Inland Transport Committee

Review of recommendations on A through F signs

Proposal for amendments to Annex 1 and 3 of the 1968 Convention on Road Signs and Signals

Submitted by the Secretariat

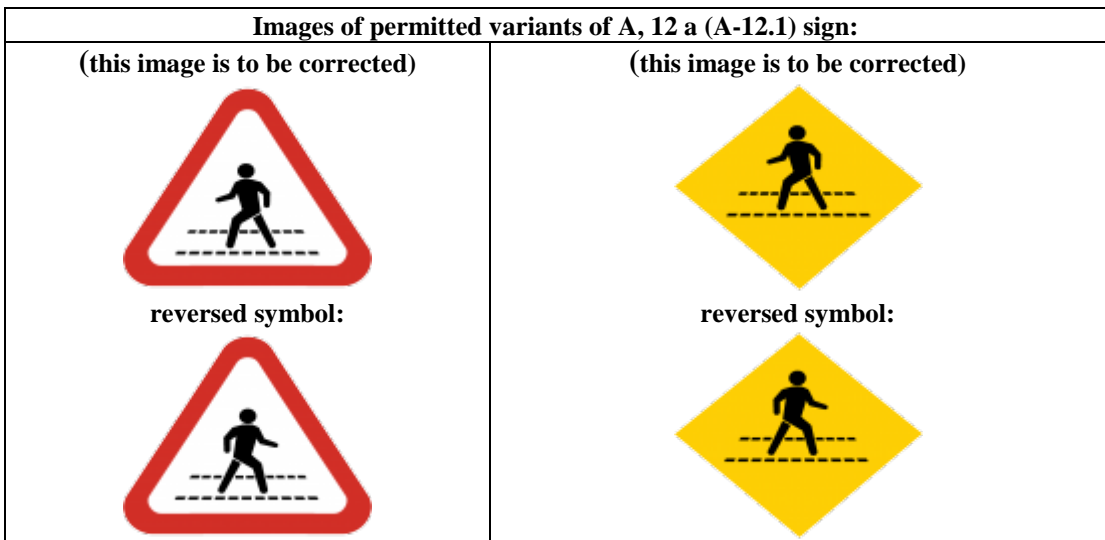
(a) Warning of a pedestrian crossing indicated either by road markings, or by signs E, 12 shall be given by symbol A, 12 of which there are two models: A, 12a and A, 12b.

(b) The symbol may be reversed.

Image of a permitted variant of A, 28 c (A-25.3) sign:

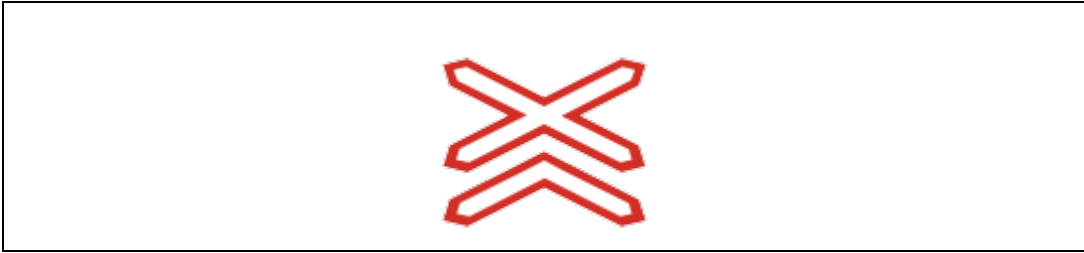
A, 28 c (A-25.3) gives warning of immediate vicinity of a level-crossing with at least two tracks. It is identical to the sign A, 28 a (A-25.1) except that it is supplemented by half of an X-shaped cross affixed below. It can be replaced by sign A, 28 d (A-25.4).

APPROACHES TO LEVEL-CROSSINGS OR SWING BRIDGES

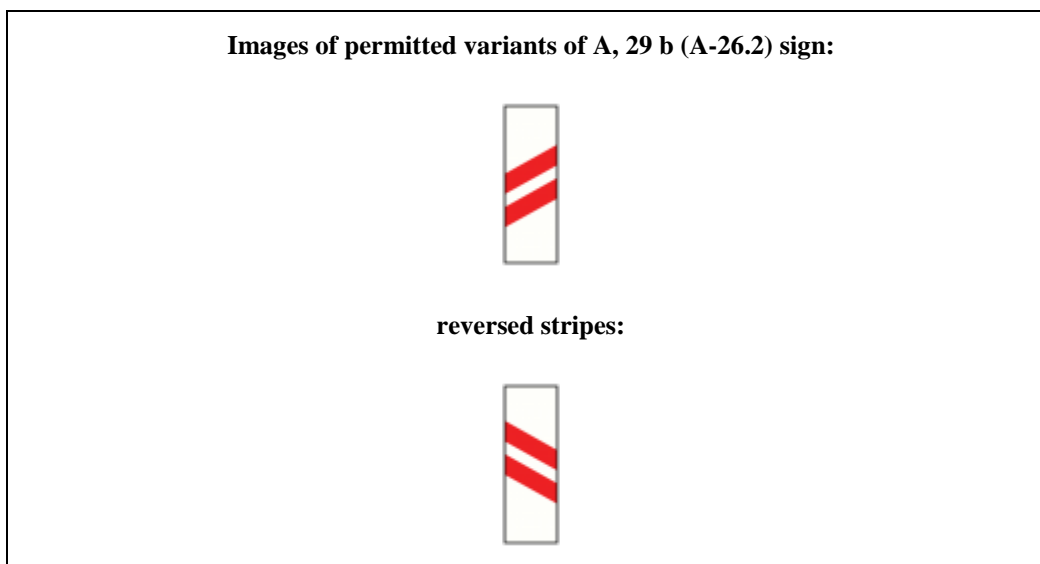
A, 29 b (A-26.2) gives warning of and distance at approaches to level-crossings and swing bridges. It is a rectangle having its longer sides vertical and bears, preferably centered, two oblique red stripes on a white or yellow ground. It is set up at about two thirds of the distance between the railway line or swing bridge and the sign A, 29 a (A-26.1). It may be repeated on the opposite side of the carriageway. The stripes shall slope downwards towards the carriageway. The signs A, 25, A, 26 a, A, 26 b, A, 27 or A, 5 (A-23.1, A-23.2, A-23.3, A-24.0 and A-05.0) may be placed above this sign.

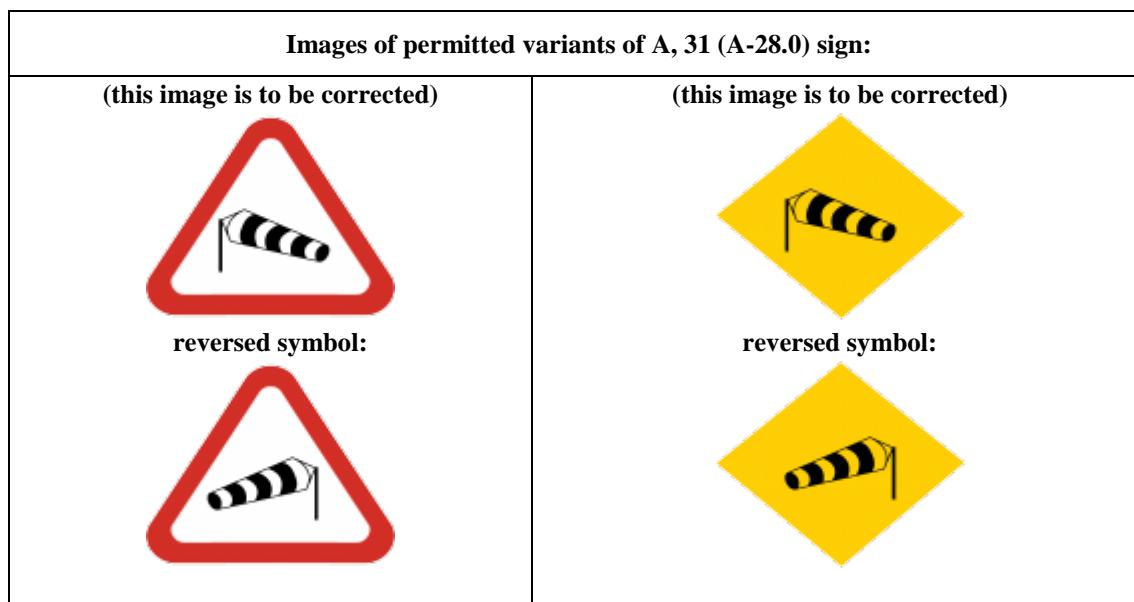
- (a) ~~Warning of a section of road on which there is often a strong cross wind shall be given by symbol A, 31.~~
- (b) ~~The symbol may be reversed.~~

A, 31 (A-28.0) gives warning of a section of road on which there is often a strong cross-wind. The symbol on this sign may be reversed.

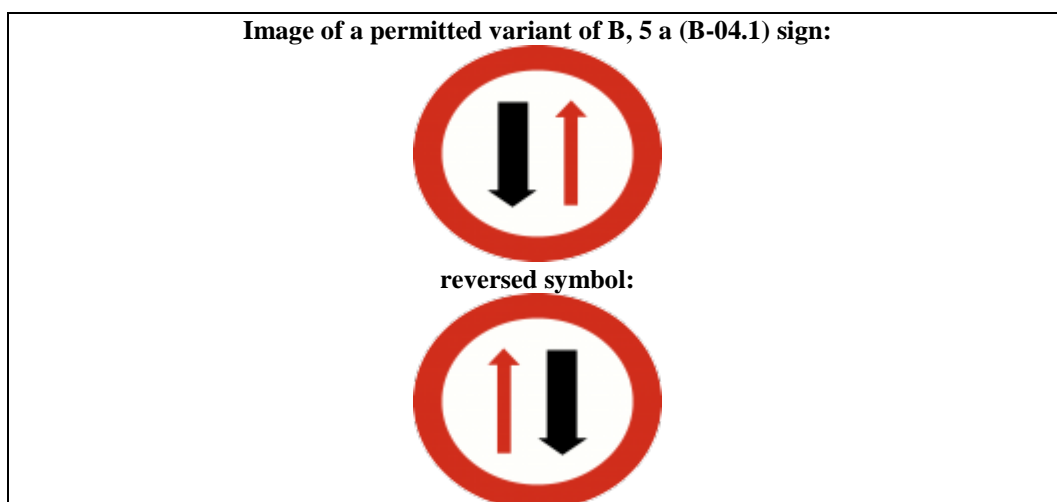
(a) ~~If, on a narrow section of road where passing is difficult or impossible, traffic is regulated and if, because drivers can see the whole length of the section clearly both at night and by day, such regulation is carried out by giving priority to traffic moving in one direction and not by installing traffic light signals, sign B, 5 "PRIORITY FOR ONCOMING TRAFFIC" shall be set up facing the traffic on the side which does not have priority. This sign shall mean that entry into the narrow section is prohibited so long as it is not possible to pass through that section without obliging oncoming vehicles to stop.~~

(b) This sign shall be round, with a white or yellow ground and a red border; the arrow indicating the direction having priority shall be black and that indicating the other direction red. **The arrows shall be placed parallel one to another.**

**END OF PROHIBITION OF OVERTAKING**

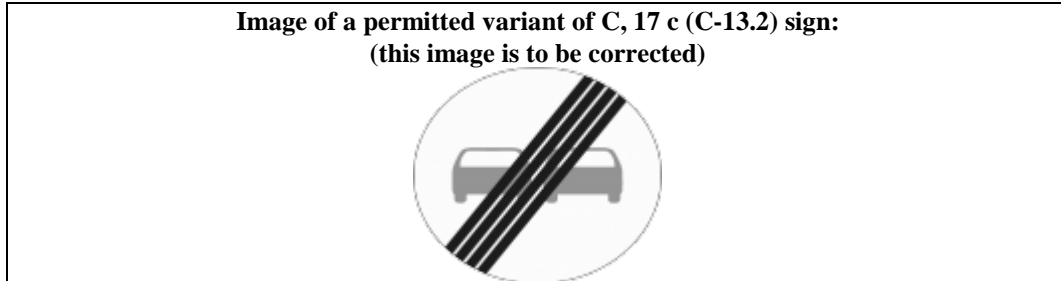
This sign shall be circular and have a white or yellow ground; ~~it shall have no border or only have preferably a black rim;~~ **it shall show in light grey the symbol of the prohibition of overtaking which has ceased;** and shall bear an ~~oblique diagonal~~ black band or preferably, black parallel lines forming such a band, sloping downward from right to left, ~~which may be black or dark grey or, preferably, consist of black or grey parallel lines forming such a band.~~ **The diagonal oblique band can may be interrupted when**
